**IR 32**

## IR 46-R1 (Confirmation of Information in May 2024 Revised EIS)

### **Part 1 of the IR comment correspondence from the CNSC re: IR 46-R1 from 12 November 2024:**

**Inclusion of information from Figure 2 of Attachment IR 46-R1 in the May Revised EIS:**

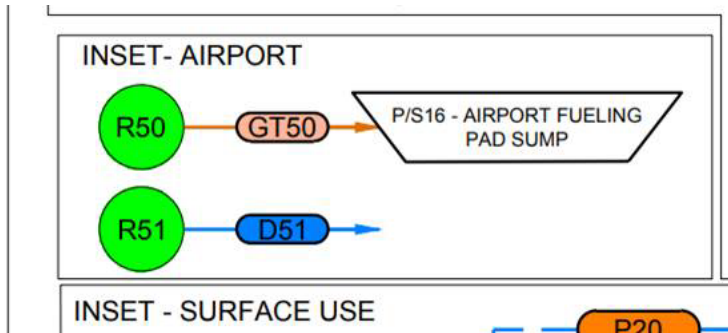
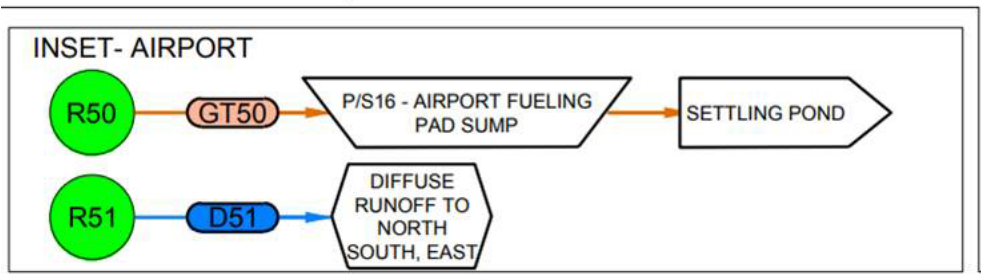
In summary, the changes committed to in the Revised EIS required the inclusion of elements of Figure 2 into Figure 5 of revised EIS TSD XVIII (Site-Wide Water Balance and Water Quality Modelling Report) and making the correction to element R52 in Figure 5 of revised EIS TSD XVIII to show non-contact water rather than contact water. The images below present where these changes have been made from Draft EIS to revised EIS.

Draft EIS Figure 5 of TSD XVIII

May Revised EIS Figure 5 of TSD XVIII

**Correction for Element R52 made in the May Revised EIS:**

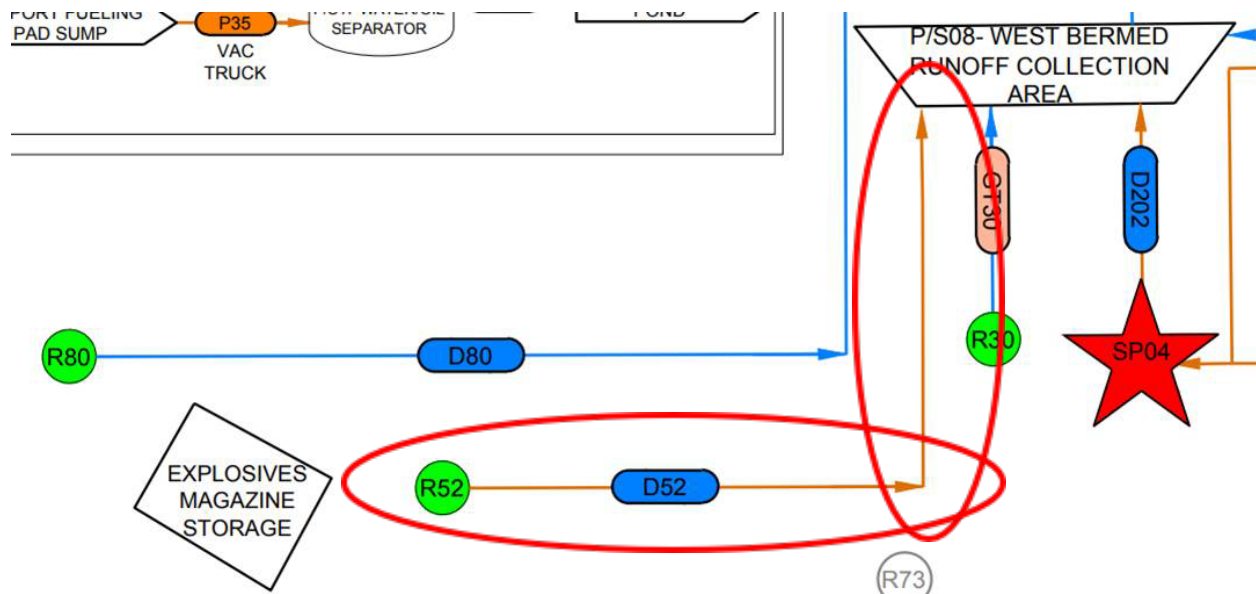
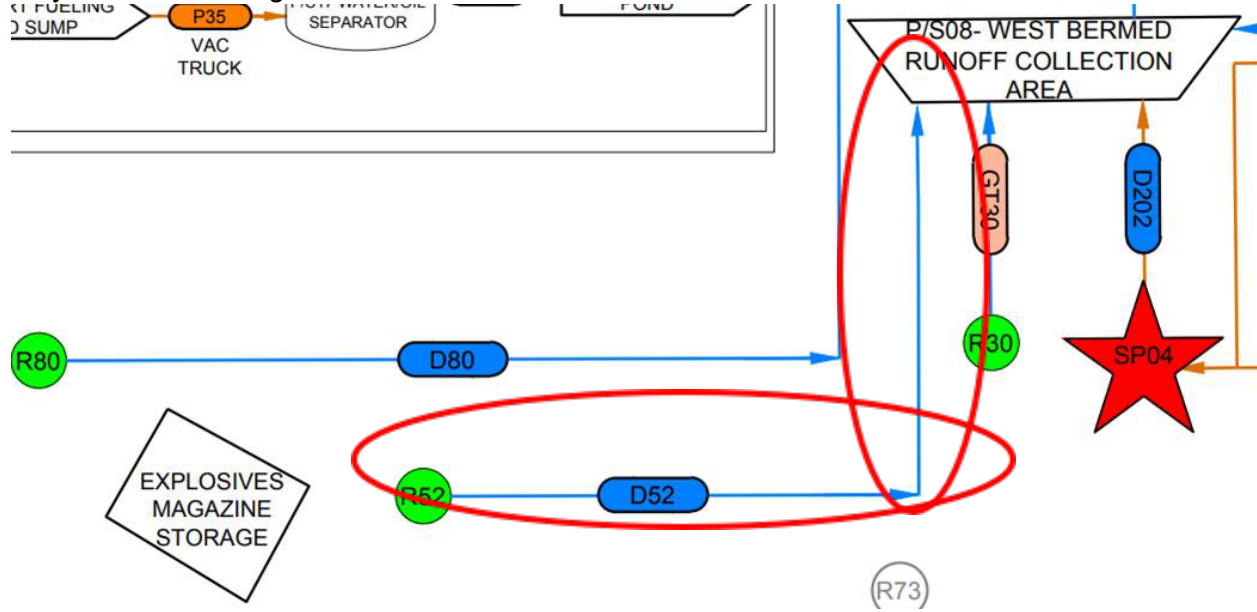
NexGen notes that Figure 5 of Draft EIS TSD XVIII incorrectly shows that Element R52 would contain mineralized contact water rather than non-mineralized contact water; this will be corrected in Figure 5 of revised EIS TSD XVIII.

Draft EIS Figure 5 of TSD XVIII

May Revised EIS Figure 5 of TSD XVIII

Figure 10.5-8: Application Case Cobalt Concentration in Patterson Lake North Arm – West Basin, Patterson Lake South Arm, Forrest Lake – North Basin, and Beet Lake

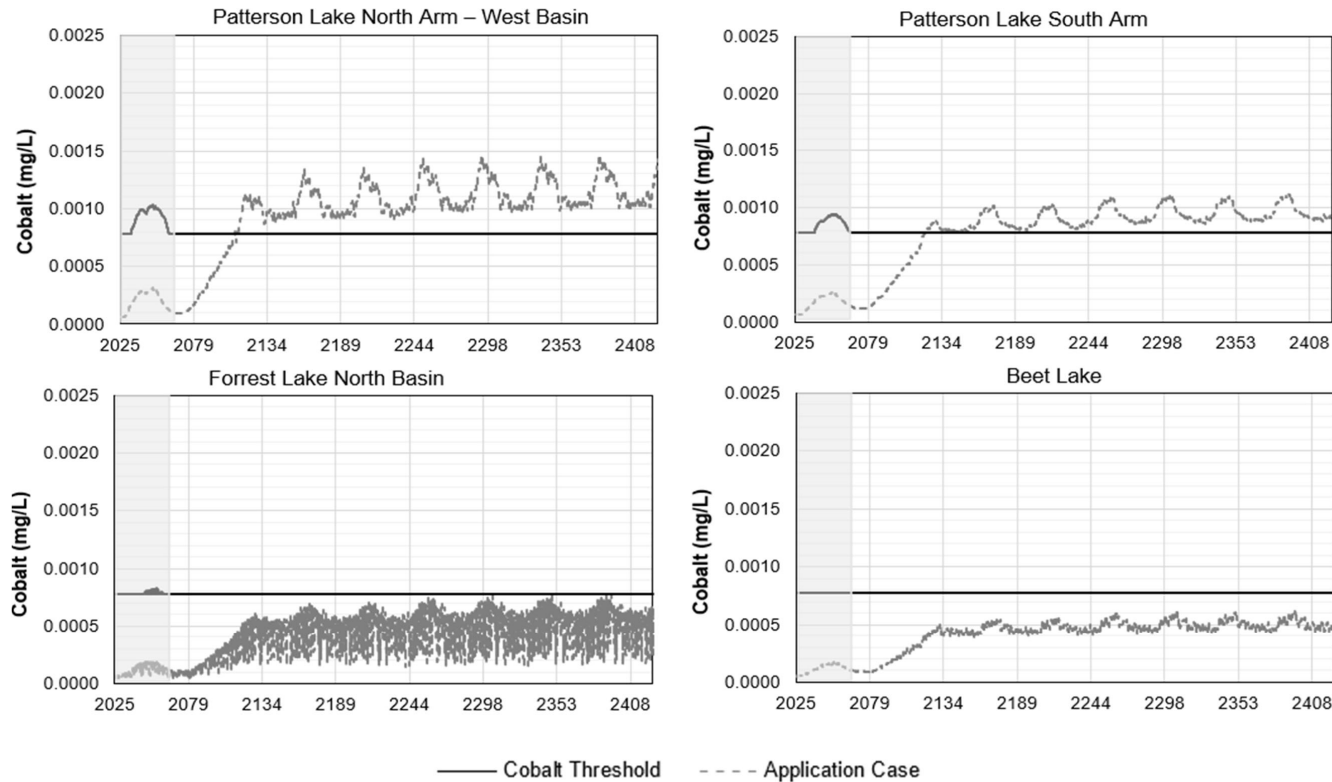
**Commented [LM35]:** Change related to IR 89-R1 from 22 October 2024 comment table from CNSC.

Figure 10.5-19: Reasonably Foreseeable Development Case Copper Concentration in Patterson Lake North Arm – West Basin and Patterson Lake South Arm

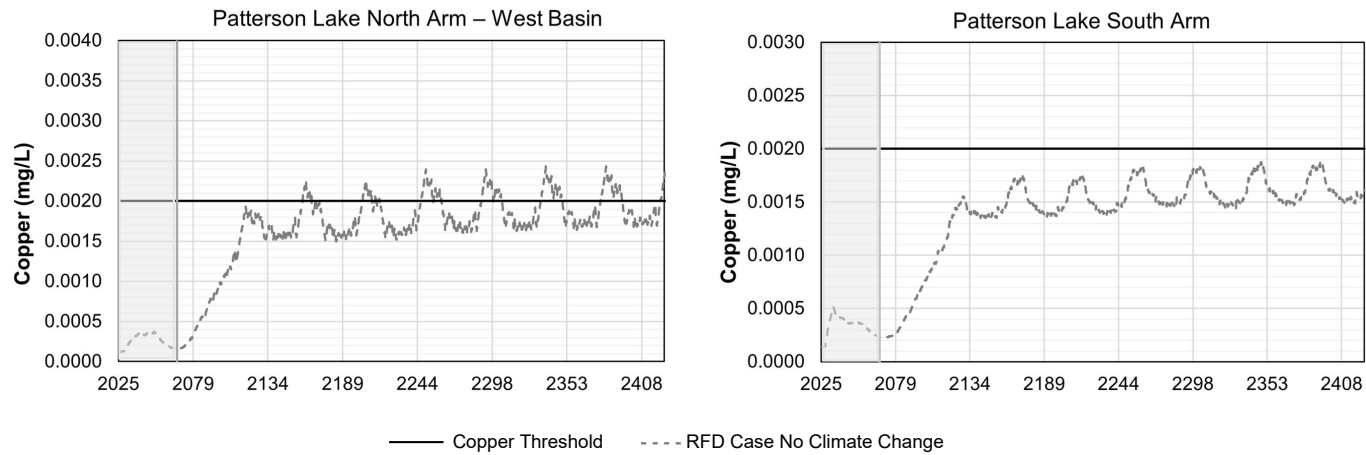
**Commented [LM38]:** Change related to IR 89-R1 from 22 October 2024 comment table from CNSC.

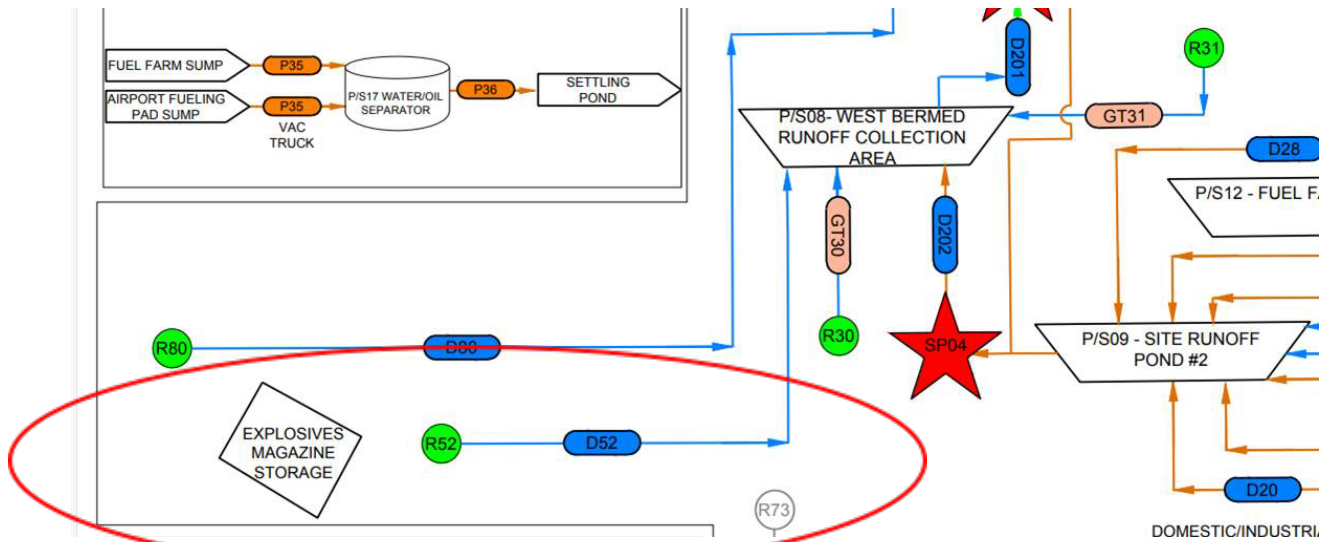
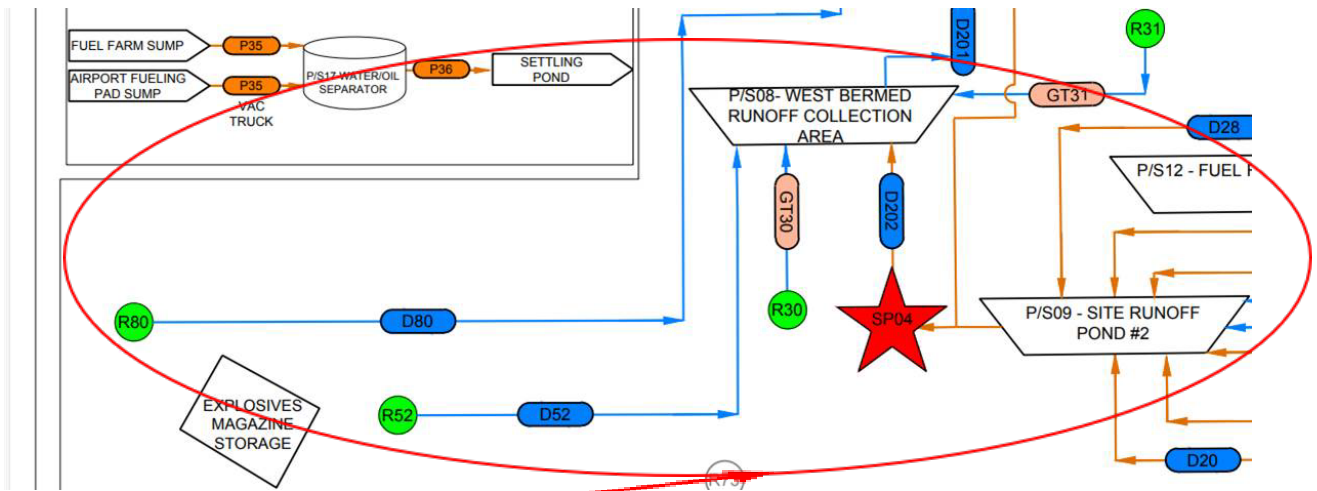
With respect to changes in the EIS to address part 1 and part 2 of IR 244-R1, NexGen confirms that edits were already incorporated in the May Revised EIS. Please see below the changes that were presented in the May Revised EIS, with identifiers (i.e., circles, highlighting, text box) included to show the necessary aspects.

Figure 5 of Section 3.4 of revised EIS TSD XVIII (Site-Wide Water Balance and Water Quality Modelling Report) to show the Project site water process flow more clearly.
